ADDENDUM NO. 1

**Construct Battery Room
Trenton Field Maintenance Shop
Trenton, Missouri
PROJECT NO.: T2026-01**

CONSTRUCT BATTERY ROOM

TRENTON FIELD MAINTENANCE SHOP

SK-1

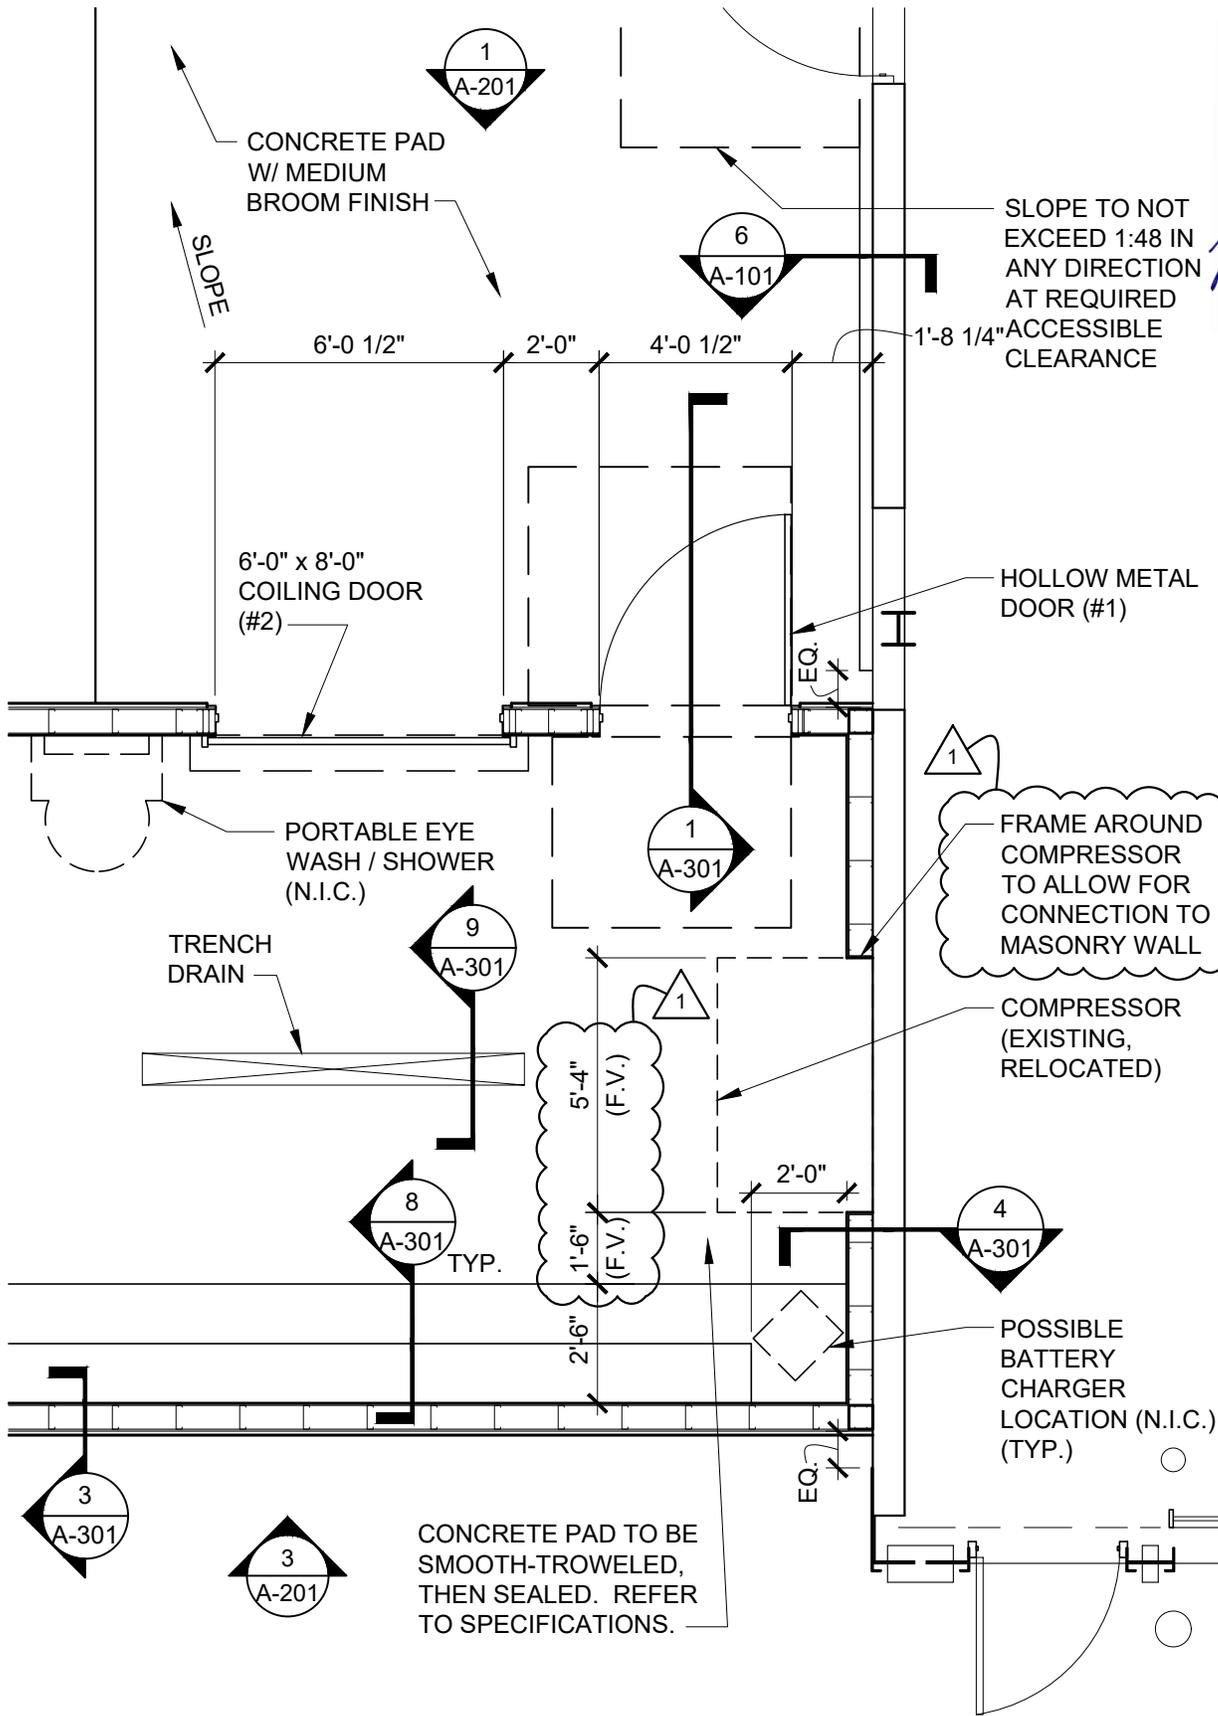
1. SHEET A-101
 - a. REVISE Note in Detail 2 as shown on attached supplemental sketch SK-1.
 - b. ADD Note and Dimensions to Detail 4 as shown on attached supplemental sketch SK-2.
2. SHEET E-101
 - a. ADD the following Note to Detail 1:

REMOVE AND PROTECT EXISTING COMPRESSOR. PREPARE FOR RELOCATION PER 3/A-101. RE-INSTALL COMPRESSOR ON NEW CONCRETE SLAB WITHIN 5 WORK DAYS OF REMOVAL TO AVOID SIGNIFICANT DOWNTIME FOR SHOP STAFF.
